Reviewers' comments (Oct. 11th, 2017)

Reviewer #1: Dear Author, please find here a list of comments from my side.

Summary: the article describes the layout, operation and performances of a Radial Time Projection Chamber with the electron amplification stage provided by three layers of GEM. The main novelty is the application of the electron multiplier for the amplification stage in a TPC on a semi-cylindrical shaped plane. The detector, originally built for the BoNuS experiment, is in fact formed by two semi-cylindrically shaped halves connected together, with the axis coincident with the beam line.

Figure 1: The number of active pads versus the measured momentum of the elastic ^4He tracks.

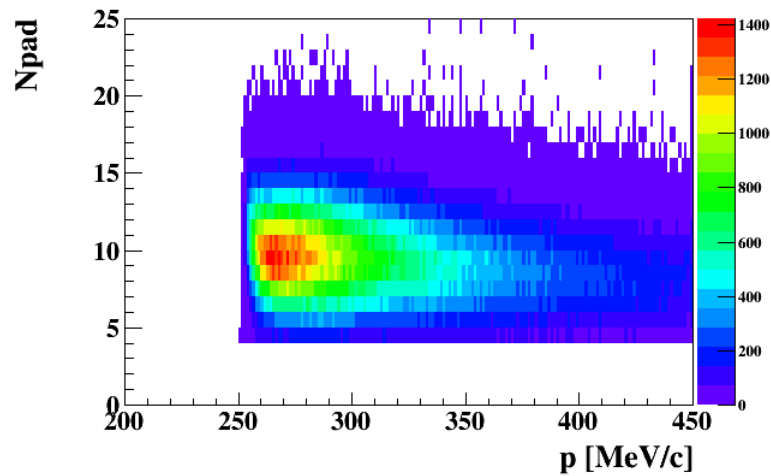
16. Figure 11: I don't understand it. How many tracks does the histo contain? If the single pad has 128 channels, how many channels does the single bin contain? Moreover, is the dE calculated on pad by pad basis? In that case, why don't you put just one point in the histo for each pad? What is the mean number of channels or pads fired by one track? Sorry for the list of questions, but I could not understand the figure.

- It is for only one track (written in the caption). - We dont understand your second question. A pad is a channel. Do you mean how many pads are fired for a single track? Figure ?? shows the number of active pads as a function of the momentum for the collected elastic ^4He tracks.

- dE is calculated from the ADCs of the individual pads that read out hits corresponding to the same track. One needed to know the individual step size very precisely to put dEdx from the individual pads, which is not available. - Last question is addressed by figure ??.

The mean value is around 10 pads.

Figure 2: the number of hits distribution for the collected elastic ^4He tracks from the 1.2 GeV dataset.

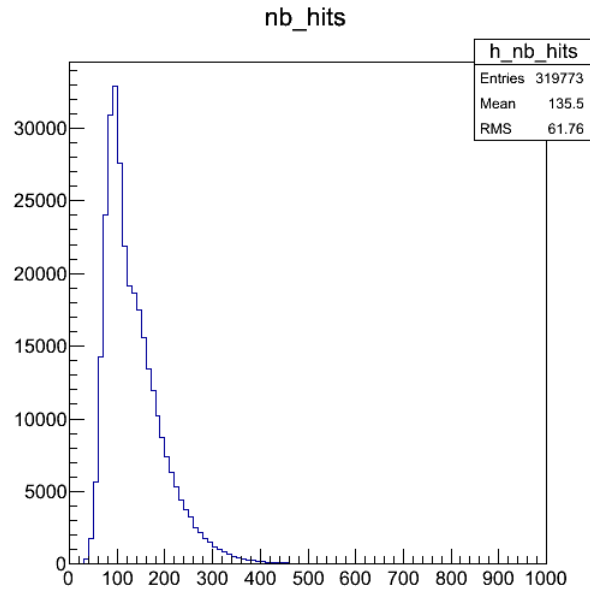
20. How was the "10 hits" cut chosen? What is the mean number of primary ionization in this gas mixture?

Figure 2 shows the number of hits distribution for the collected elastic ^4He tracks from the 1.2 GeV dataset. The mean number of hits is around 135 and the 10 hits cut at the reconstruction level is a loose cut to reduce the level of the spurious tracks.
